**DEVIATION REVIEW
 AND DECISION FORM**

**Deviation No. 1
 REV 2-8-19**

Subdivision or Project Name: Rollin' Ridge

Section of ECM from Which Deviation is Sought: 2.3.2 Design Standards by Functional Classification

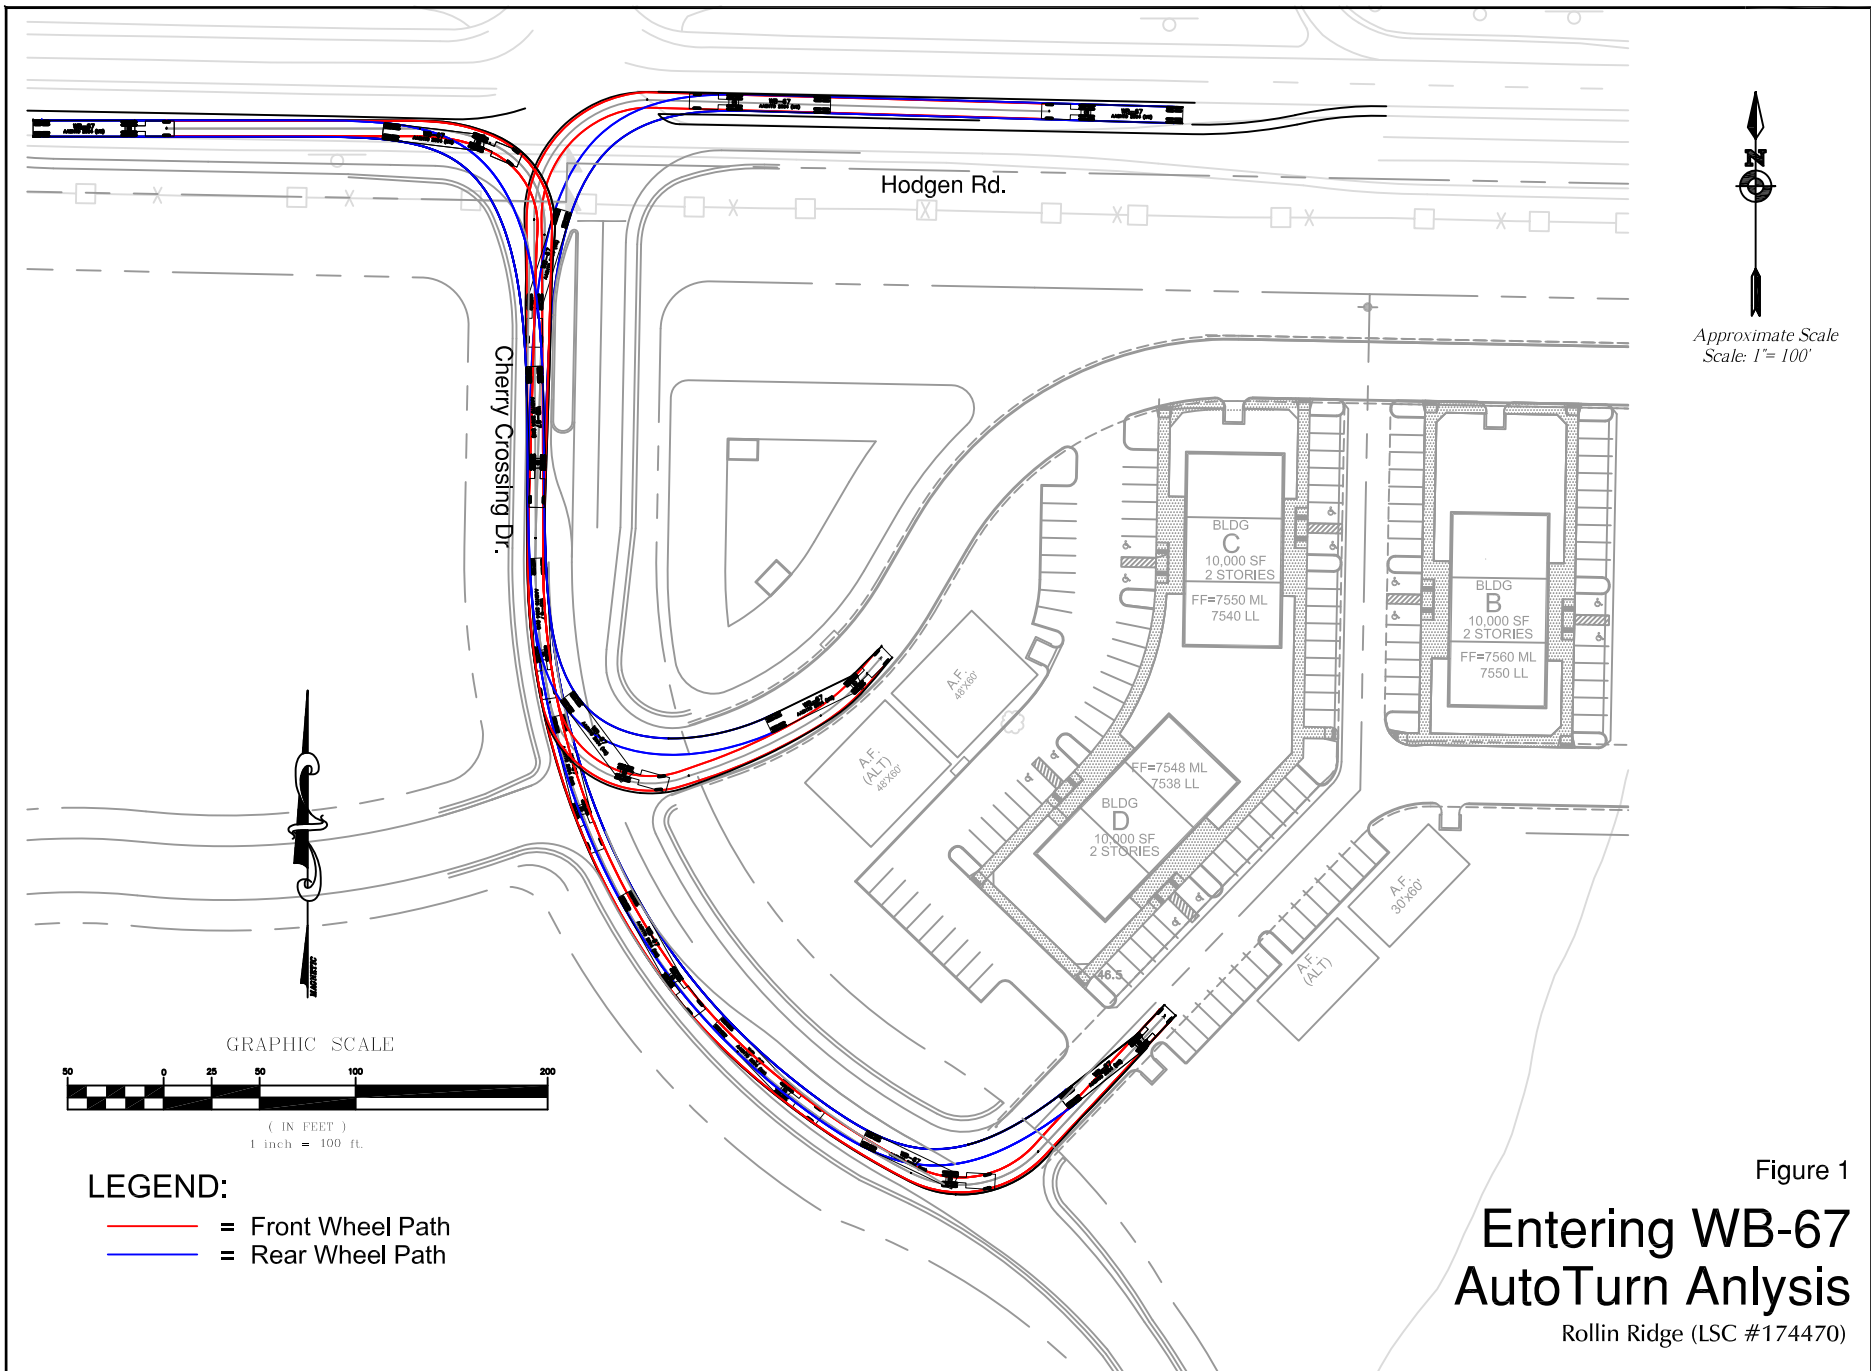
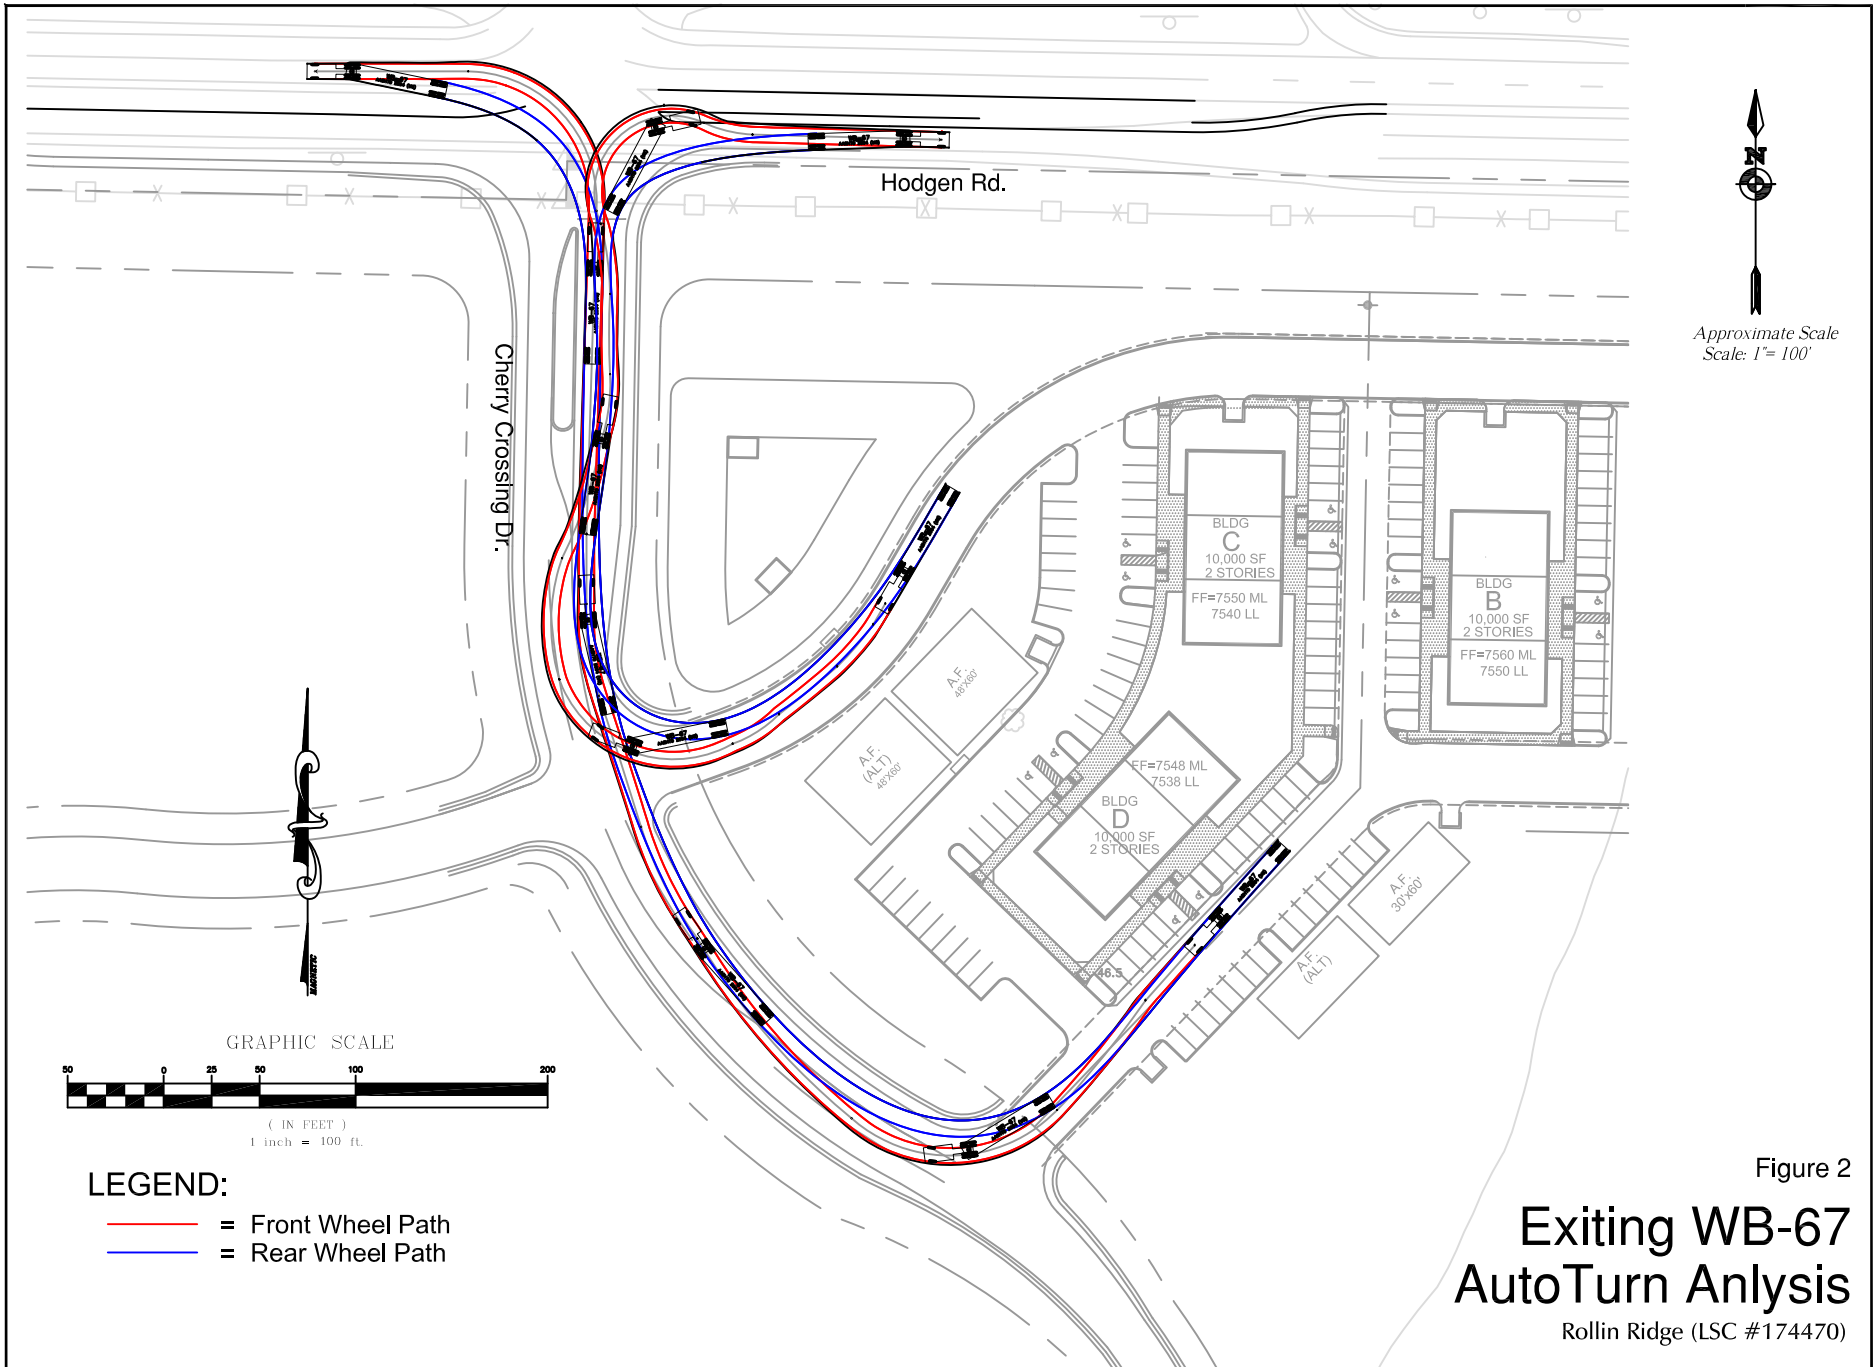
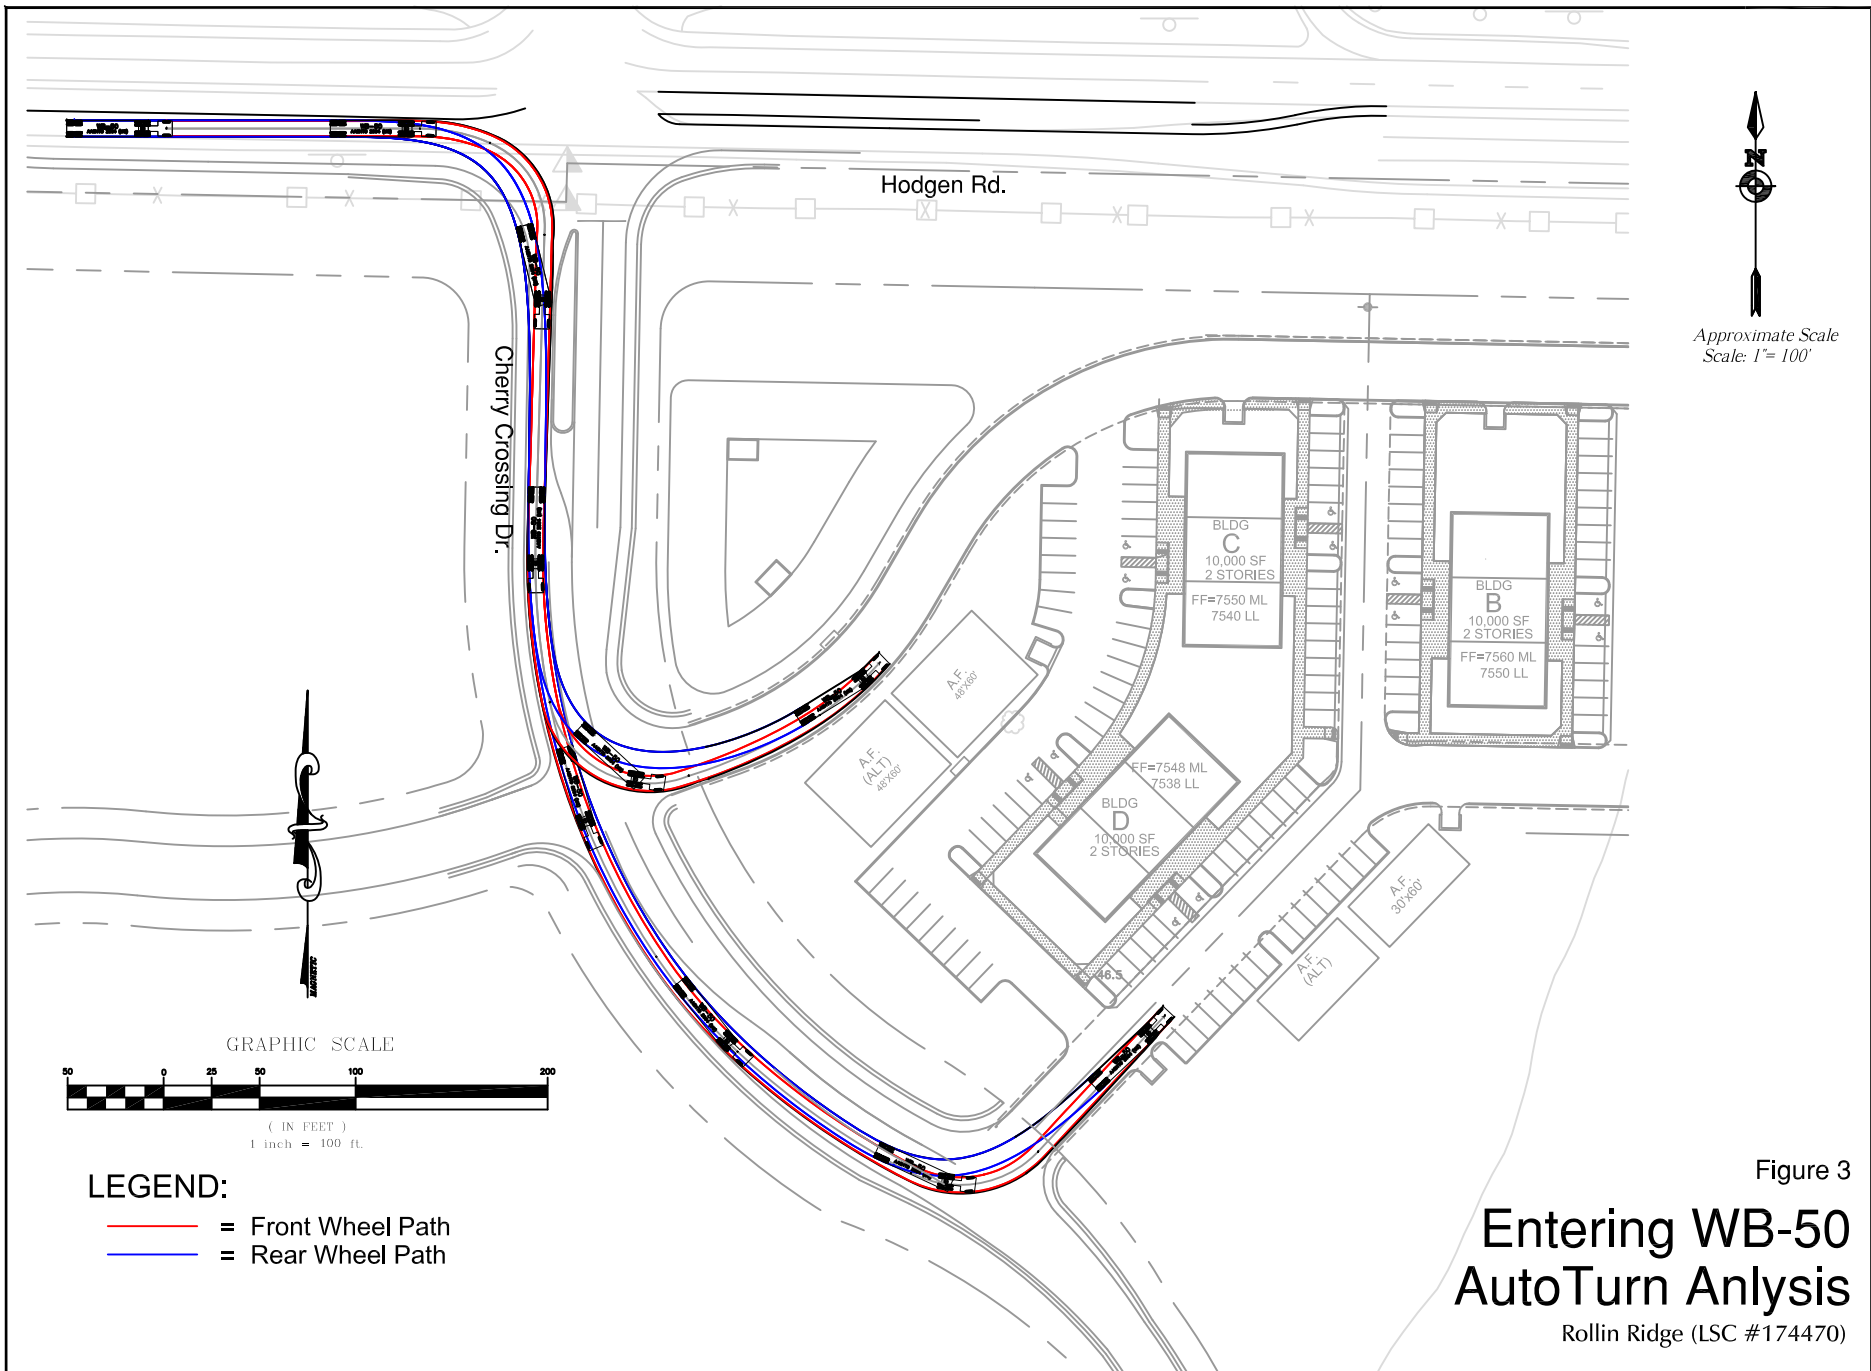
remove reference to intersection spacing, it is in deviation 2.
 This should be the only deviation with the turning movement exhibit (because of the narrower shoulder).
 Lane width should be discussed for clarification.
 Ditto comment on exhibits as stated in deviation 2.
 A

remove reference to intersection spacing, it is in deviation 2.
This should be the only deviation with the turning movement exhibit (because of the narrower shoulder).
